**Subject: Response to Comments
Purple Wine+Spirits Environmental Noise Assessment & Addendum Reports**

Illingworth& Rodkin, Inc. (I&R) has the following responses to the comments on our Environmental Noise Assessment and Addendum reports which examines the noise impacts resulting from operational changes, consolidation at the existing Purple Wine + Spirits (PW+S) facility in Graton California. The comments received and our responses are presented in the following letter:

Figure 1: Near the earth sound propagation pathways

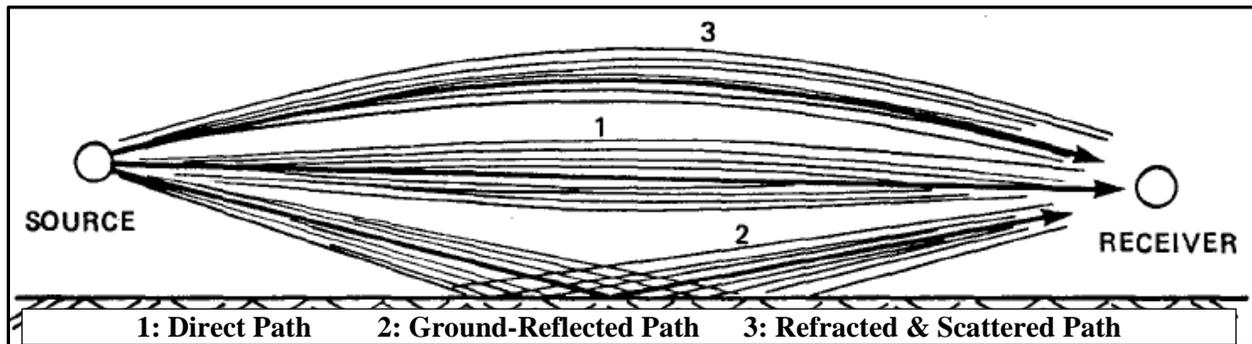
The commenter takes issue with our analysis because of the contention that, “aerator sound is totally dependent on weather conditions such as wind direction and inversion layers.”.

The commenter also contends that there are amplification effects that occur when sound carries in wind currents, and/or reflects off of atmospheric inversion layers. We agree that the transfer of sound in the open environment can be influenced by weather conditions such as wind direction and inversion layers. While we would acknowledge that there may be some atmospheric reflected sound from the project source which may arrive out of phase with direct sounds, the effect of this reflected sound would not increase the overall sound levels calculated using the predicted using sound divergence model.

As further explanation of this, we submit that sound transmission near the earth's surface involves essentially three types of sound paths, shown conceptually in Figure 1. The direct path (path 1) is the normal path by which most of the sound energy travels. There is actually no single straight-line path from source to receiver. Instead, there are a multitude of paths (shown by the "bundle" of lines) that make up path and converge to the receiver, especially for long distances. Some of the

ground-reflected sound (path 2) may arrive at the receiver either in or out of phase (or at various other phase angles) with the direct sound (path 1) and can either increase or decrease the received sound level. The ground surface may be hard or soft (reflective or absorbent), and this also effects the phase and magnitude of the reflected path. Paths 1 and 2 usually determine the sound levels at the receiver, but a solid barrier such as intervening terrain or buildings can intercept and practically eliminate these paths. In such situations, Path 3, which is made up of relatively low-level sound that is refracted (bent) or scattered back to earth by numerous small patches of inhomogeneous air of varying temperature, speed, direction, density, etc. may become significant. However, field studies show that when paths 1 and 2 are virtually eliminated the remaining reflected (path 3) sound levels that are up to 20 to 25 dB¹ below the path 1 and 2 sound levels),
